Subject: Radio, Insufficient Bass Output (BE)

Number: 04-06

Model(s): Touareg with Radio Navigation 2004 ► 7L94D015720
System (Sound II)

Date: May 17, 2004

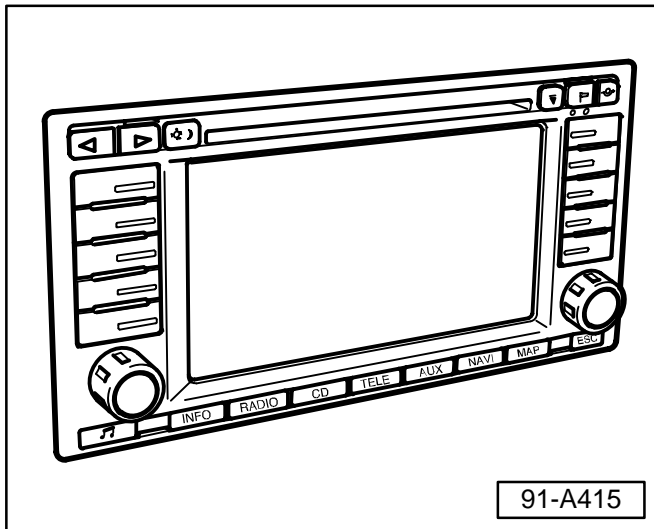
◀ On all Touareg's equipped with radio/navigation system (Sound II) built prior to VIN: 7L94D015720:

- Replace with new radio amplifier, Part No. 7L6 035 466. See Repair Manual, *Repair Group 91, Amplifier, Removing and Installing.*
